Project	IEEE 802.16 Broadband Wireless Access Working Group < <a href="http://ieee802.org/16">http://ieee802.org/16</a> >		
Title	Extension of collaborative spatial multiplexing in OFDMA		
Date Submitted	2005-01-26		
Source(s)	Bin-Chul Ihm, Yongseok Jin, Jinyoung Chun, Kyuhyuk Chung	Voice: 82-31-450-7187 Fax: 82-31-450-7912	
	LG Electronics, Inc. 533, Hoge-1dong, Dongan-gu, Anyang-shi, Kyongki-do, Korea		[mailto: {bcihm, jayjay, jychun03, kyuhuk} @lge.com]
	<b>Chan-Byoung Chae, Wonil Roh</b> <b>Samsung Electronics Co., Ltd.</b>		[mailto: ch.chae@samsung.com]
	Ran Yaniv, Tal Kaitz Alvarion Ltd.		[mailto: {ran.yaniv, tal.kaitz} @alvarion.com]
Re:	This is a response to a Call for Comments on IEEE P802.16e-D5a		
Abstract	The collaborative spatial multiplexing can be applied to the case in OFDMA.		
Purpose	This document is submitted for review by 802.16e Working Group members. <b>Pink line indicates the revised text.</b>

# Extension of Collaborative Spatial Multiplexing in OFDMA

**Figure 2. The case of two SSs with dual transmit antennas**

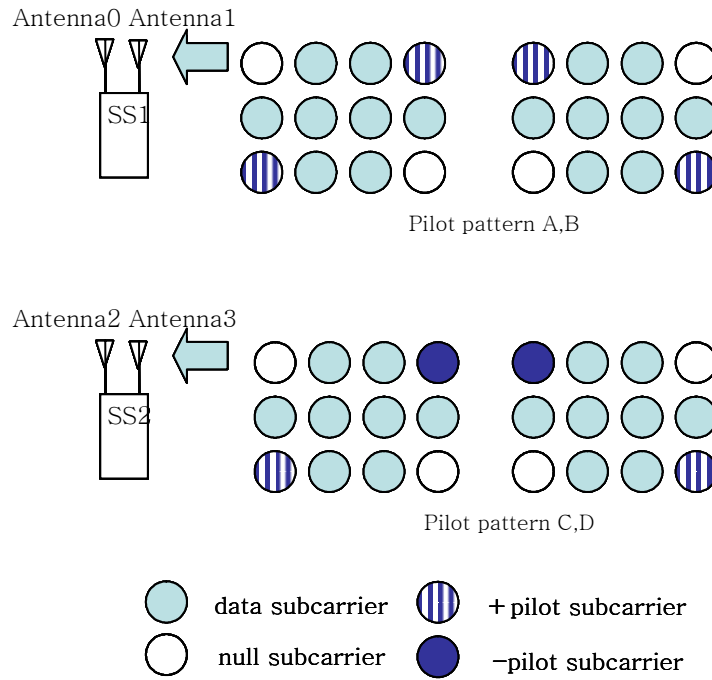
A SS1 uses the uplink tile with pattern A and B, and a SS2 uses the uplink tile with pattern C and D.

The second example of the aforementioned collaborative SM examples requires four pilot patterns to distinguish the channels from each antenna of MSSs. For the purpose of realizing the above configurations, more pilot patterns are needed to support the various collaborative SM modes. Therefore, we propose to add new pilot pattern C, D to current pilot pattern A, B as shown in Figure 2.

[Figure 249a – Pilot Patterns in UL PUSC tile](#)

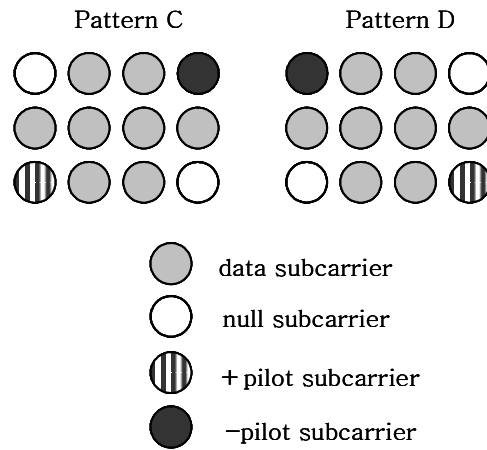
*[Insert Figure 249a after Figure 249 as follows:]*

Two single transmit antenna SS's can perform collaborative spatial multiplexing onto the same subchannel. In this case, the one SS should use the uplink tile with pattern-A and the other SS should use the uplink tile with pattern-B. [Also, two dual transmit antenna SS's can perform collaborative spatial multiplexing onto the same subchannel. In this case, the one SS should use the uplink tile with the pilot pattern A, B and the other SS should use the uplink tile with the pilot pattern-C, D through ~~MIMO-UL Basic IE~~ \*\*MIMO UL Enhanced IE\*\*.](#) Pilot patterns are illustrated in the Figure 249 and 249a.
